Palo Verde Nuclear  
Generating Station

Subject: Palo Verde Nuclear Generating Station (PVNGS)  
Units 1, 2 and 3  
Docket Nos. STN 50-528/529/530  
Response to NRC Request for Additional Information  
Regarding Request for Operating License Amendment –  
Modification to Diesel Generator Jacket Water  
Makeup System (TAC Nos. MC7288, MC7289 AND MC7290)

**APS' Response to NRC Request for Additional  
Information Regarding Request for Operating License  
Amendment – Modification to Diesel Generator Jacket  
Water Makeup System**

Figure 1 below provides a typical description of the Diesel Generator Jacket Water Standpipe for both diesel generators in all three units.

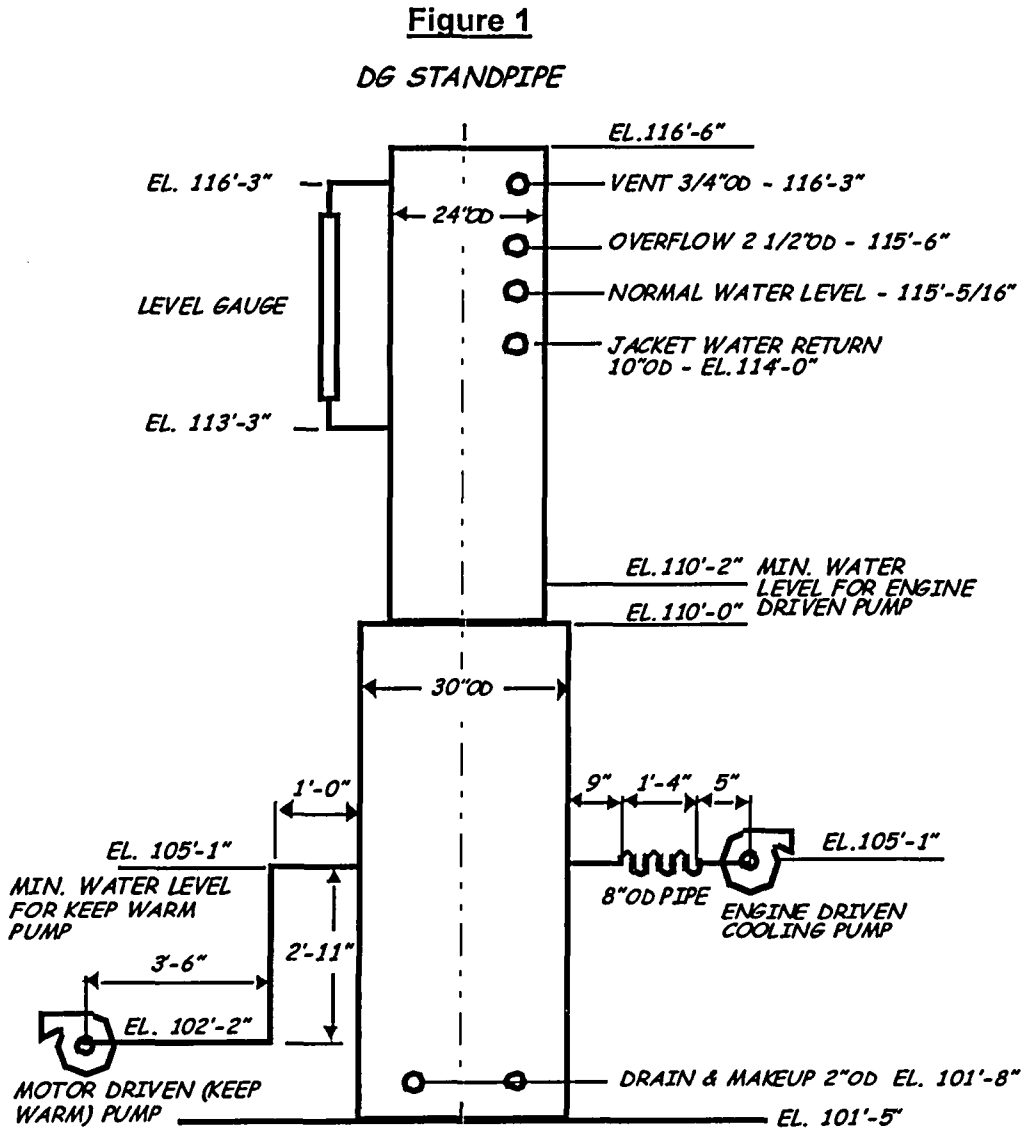
In the LAR submittal, APS states that the DGCWS is designed as a closed loop system with only a minor loss of inventory postulated during any of its operating modes, and it has an administrative allowable leakage limit of 1.6 gph. Define what the "minor loss" is, and justify how the "minor loss" and the administrative allowable leakage limit of 1.6 gph are established.

Normal or "minor loss" is defined as loss of jacket water (JW) from valve packing and/or pump mechanical seals and is predicted to be 0.124 gal/hr (gph). Leakage from valve stems is considered to be equal to the maximum allowable seat leakage (2 cm<sup>3</sup>/hr per inch of nominal valve size). Leakage from mechanical pump seals is conservatively determined to be 60 drops/min or 6 ounces per hour. Normal system evaporation of JW is considered to be negligible (less than 0.0006 gph).

The administrative allowed JW leakage rate of 1.6 gph is based on the loss of 10" of water in the JW standpipe site glass in a 12 hour period. The 10" sight glass level was chosen as it is verifiable by Operator rounds. This administrative limit constitutes a volume of 19.58 gals between the lower site glass tap-elevation of 113'-3" and a sight glass level of 10" (elevation 114'-1"). A leakage rate of 1.6 gph allows verifiable monitoring of the loss of this volume (19.58 gal) given 12-hour operator rounds. 19.58 gal/12 hours = 1.6 gph.

It should be noted that the standpipe level required to maintain minimum NPSH is 110'-2" (approximately 3 feet below the bottom tap of the sight glass). This constitutes a volume difference of 72.4 gallons between the bottom tap of the sight glass and the minimum NPSH level. This results in a maximum allowable leakage over a 25 hour period (for Appendix R considerations) of 2.9 gph (72.4gal/25 hours = 2.9 gph).

Verifying that leakage is within the administrative limit of 1.6 gph, provides a measure of confidence that the diesel generator will have an adequate volume under conditions in which no operator action is credited for 25 hrs.
